GOVERNMENT OF MADRAS.

Buildings and Roads.
Civil Works.

ORDER—No. 1762 W., dated 11th July 1898.

Name of work Certain Improvements to the Government House - Quindy

Estimate No. 1. Rs 402. The open verandah in front of the Manager's g^{rs} is proposed to be made symmetrical to the front room by adding a room on the other side and a small verandah

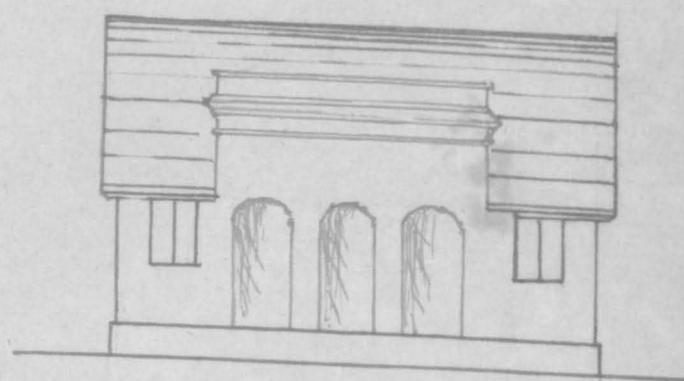
made in the centre with terrace instead of tile roof
side tracing. The proposed addition is ^{to be} founded on
concrete 2' x 3', basement of 1 foot in brick in
mortar and the structure wall of same material
and plaster 2 coats of ordinary mortar. The present
addition is a good appearance to the building.

* I think not, but on the contrary
the proposed additions appear
to be the frontage. I would
submit that the improvements
may be carried out as follows.
Room A marked in pencil, be
filled similar to room B which
will then be symmetrical & then
the front mandala with terrace
work will be like a porch thus:

otherwise insert an arch in
room B & connect the whole
frontage

✓ Leave as proposed CA
what
20.6.91
